Amendments to the Drawings:

REMARKS

FIG. 1a

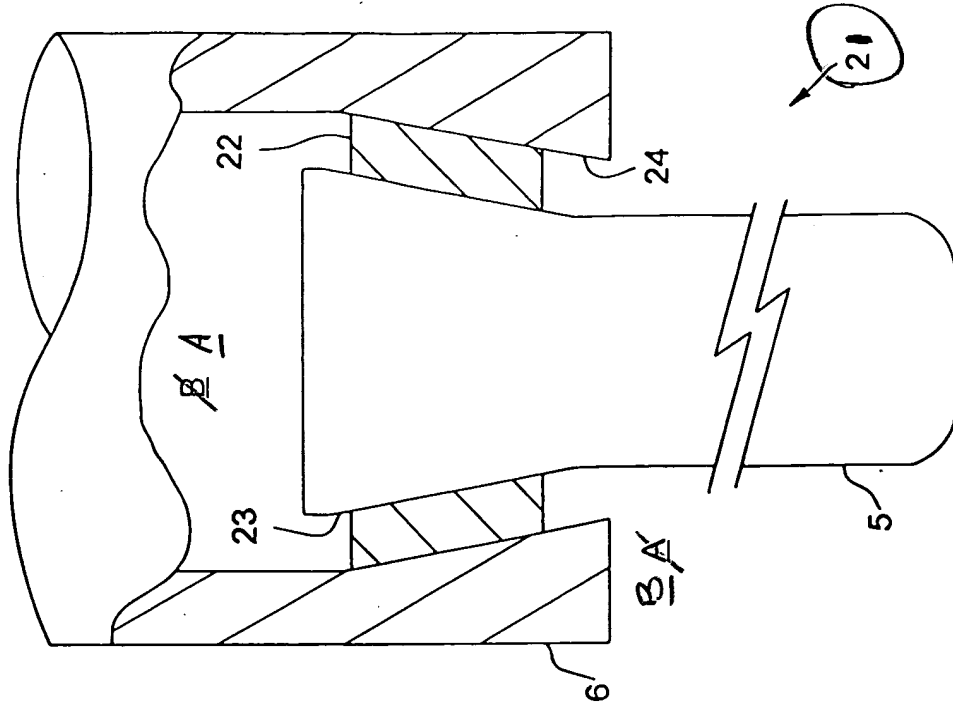
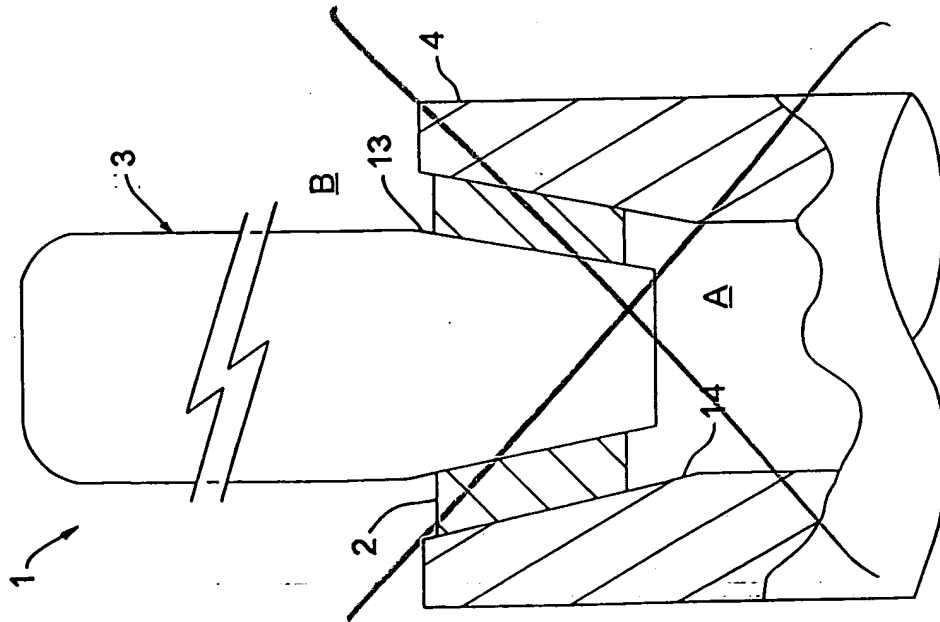
For the previous drawing depicting FIGS. 1a and 1b as originally filed (and as shown on the "Annotated Mark-Up Drawing"), Applicants are requesting to delete prior FIG. 1a as it appears redundant with FIG. 1 except for size, as noted in the Office Action. Applicants are also requesting that the remaining figure on the sheet be rotated 90 degrees and also relabeled as the new FIG. 1a. Further, Applicants are requesting that areas previously identified by "A" and "B" respectively, be reversed as also suggested by the Examiner in the Office Action. Reference numeral "2" has also been changed to – 21 – to avoid any potential confusion with reference numeral "2" also appearing on FIG. 1.

Applicants have herein requested amendment of the drawing sheet previously depicting FIGS. 1-a and 1-b, so that FIG. 1-a as originally submitted is deleted, and that FIG. 1-b as originally submitted is rotated 90 degrees and relabeled as "FIG. 1-a". Applicants have also requested that joint "2" on the previous drawing sheet be amended to a new reference numeral – 21 --, so minimize confusing that might arise relative to FIG. 1, which uses the reference numeral "2" in relation to the girdle member. Applicants have also reversed the locations identified as "A" and "B" on new FIG 1-a, to be consistent with use in FIG. 1. However, Applicants wish to point out that the use of the letters "A" and "B" in the original figures was reversed intentionally, in that location "B" was deemed to be an area of higher pressure relative to area "A". Appropriate amendments in the Specification, as

Rotate
90°

~~FIG. 1a~~
